7 Schedule of Changes Post Consent

Change From Consented Tracker & Comparative Sketches

42 Bedford Square:

42 BEDFORD SQUARE

TE DEDI OND OGOMIN	_
PROJECT NUMBER P2005698	
DRAWNING TITLE LOWER GROUND FLOOR	scale @ A3
ENTRANCE HALL	DATE
ELEVATION 02	14.05.2020
200818 SK02 LGF ELEVATION 02	REVISION

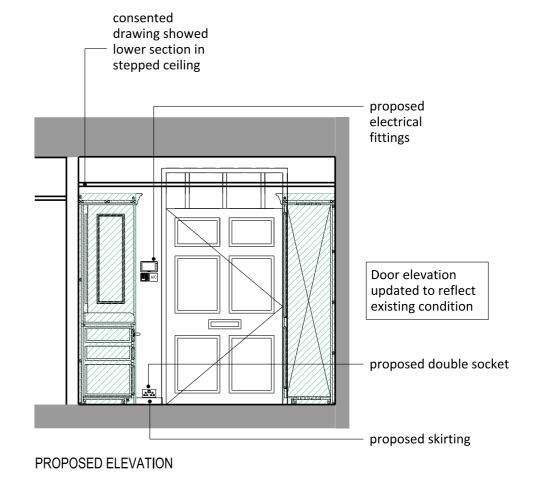
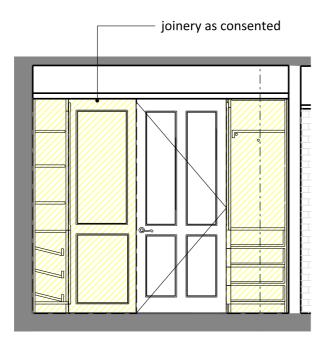
> consented dashed line drawing showed indicates existing fanlight to door. lower section in stepped ceiling Door elevation updated to reflect existing condition

PROJECT NUMBER P2005698		
LOWER GROUI	ND FLOOR	SCALE @ A3
MAIN STAIR HA		DATE
ELEVATION 03		14.05.2020
200818_SK03_L	GF_ELEVATION 03	REVISION

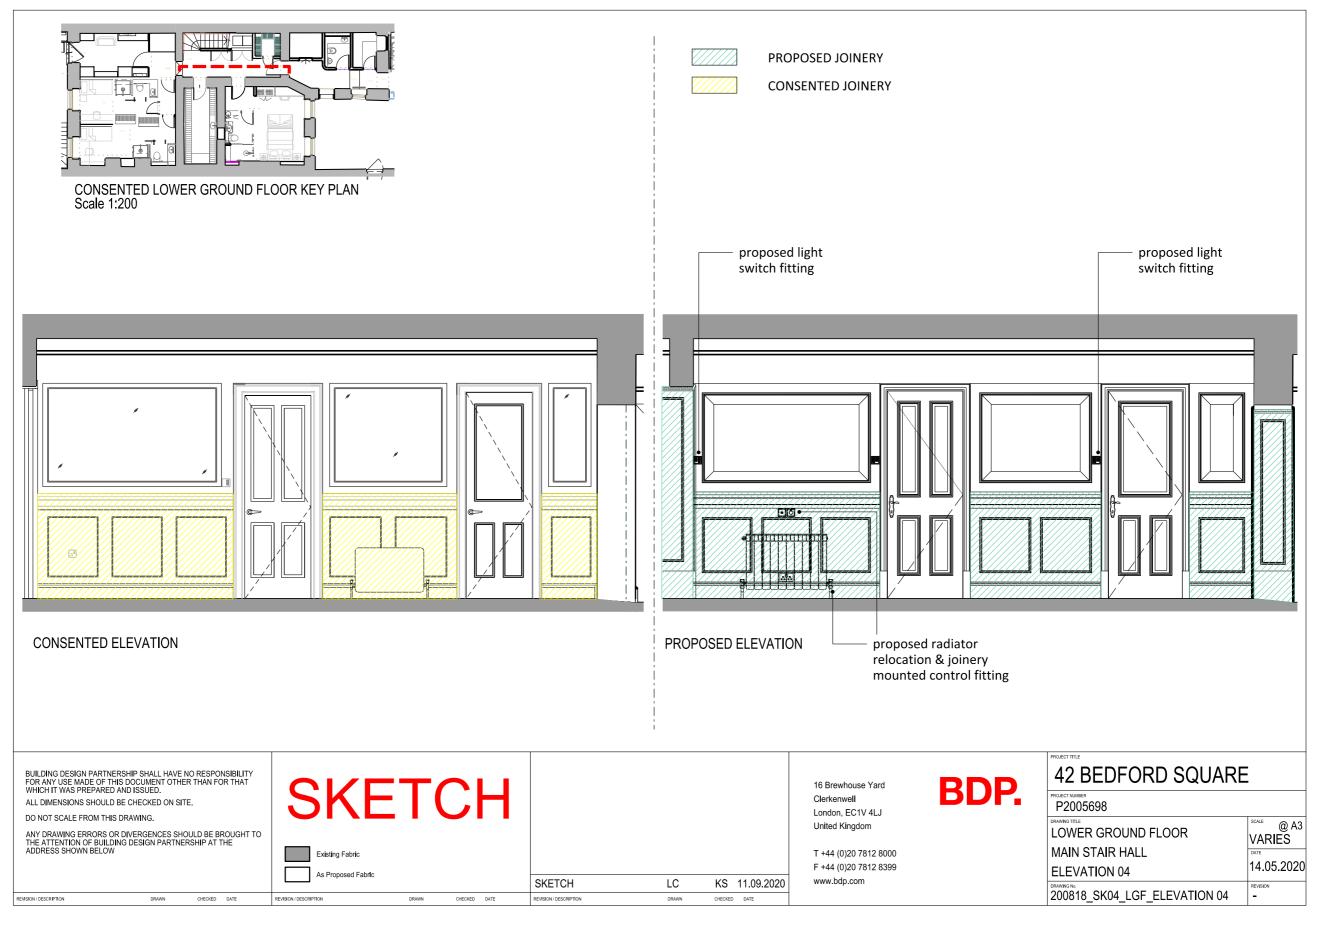
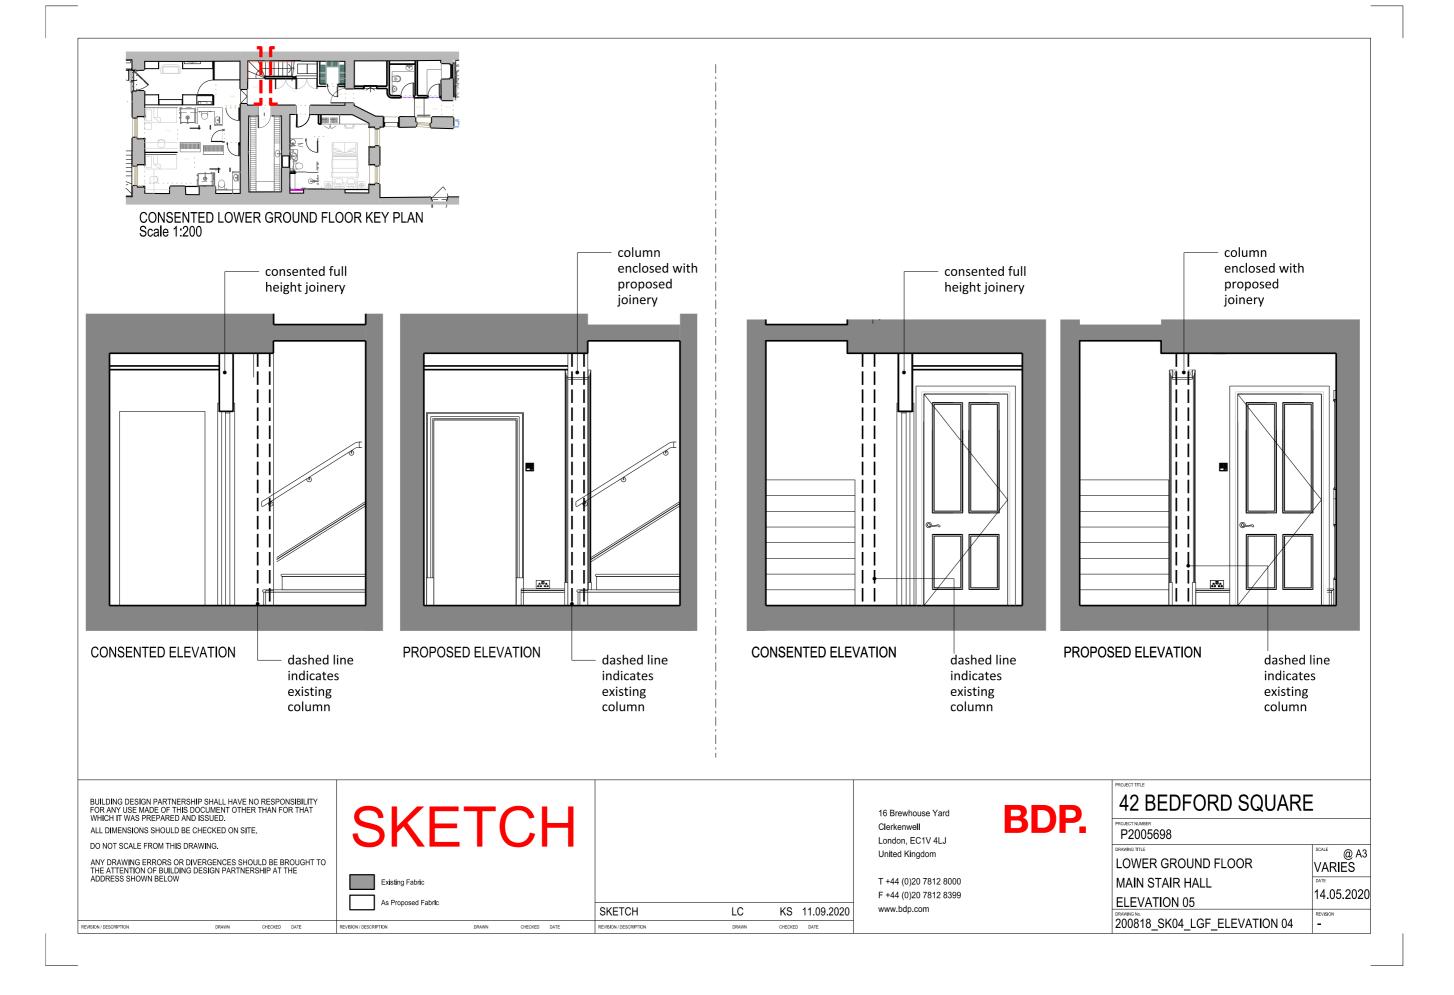
PROPOSED JOINERY **CONSENTED JOINERY** Existing column to be encased with new joinery propsed stair design. proposed panelling-Exposed balustrade & to reveal joinery to underside of stairs proposed light PROPOSED ELEVATION

PROJECT MANIBER	P2005698	
DRAWING TITLE	GROUND FLOOR	VARIES
LIVING ROOM	DATE	14.05.2020
DRAWING MG. 200911_SK02_GF_EL02	REVISION	-

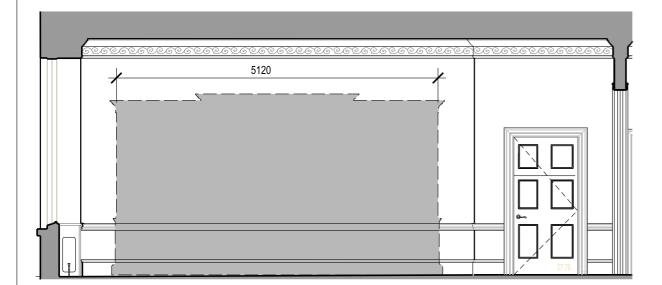
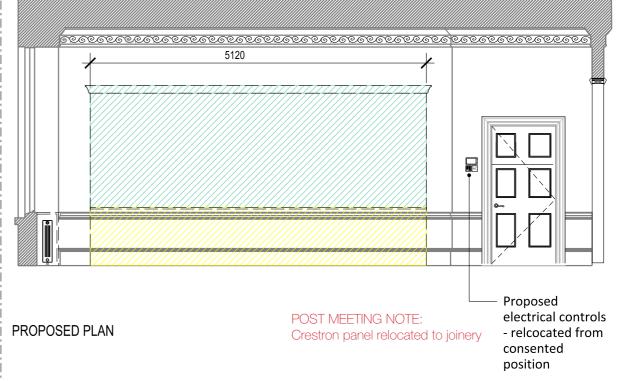
JOINERY HEIGHT TO MATCH CONSENTED

JOINERY HEIGHT TO MEET EXISTING CILL LEVEL

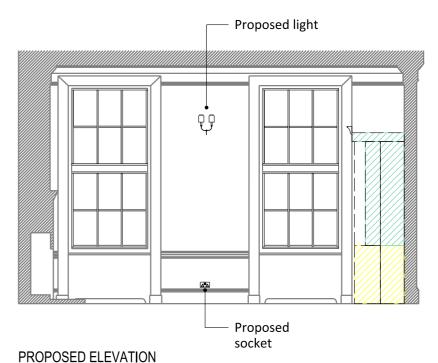
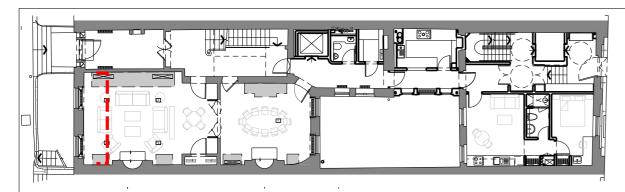
JOINERY HEIGHT TO MATCH CONSENTED

JOINERY HEIGHT TO MEET EXISTING CILL LEVEL

POST MEETING NOTE:
Proposed GA's show fixed furniture only.

42 BEDFORD SQUARE PROJECT NUMBER P2005698 @ A3 **GROUND FLOOR** VARIES **DINING ROOM** 14.05.2020 **ELEVATION 08**

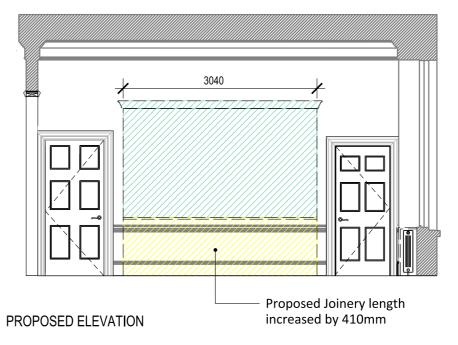
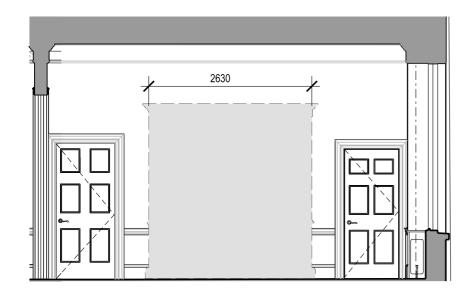
CONSENTED JOINERY JOINERY HEIGHT TO MATCH CONSENTED JOINERY HEIGHT TO MEET EXISTING CILL LEVEL

POST MEETING NOTE: Proposed GA's show fixe furniture only.

42 BEDFORD SQUARE PROJECT NUMBER P2005698 @ A3 **GROUND FLOOR** VARIES **DINING ROOM** 14.05.2020 **ELEVATION 11**

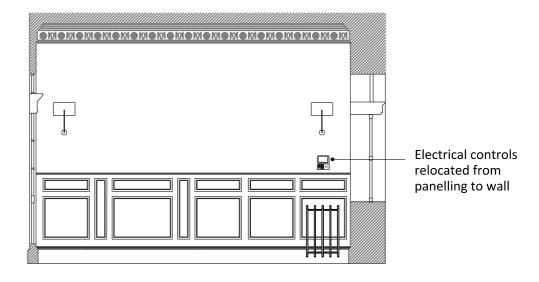
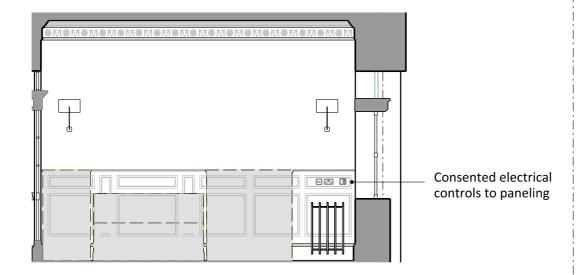
POST MEETING NOTE:

AC control, Creston panel, Fire alarm panel and Security key pad added to the scheme and located on wall. .
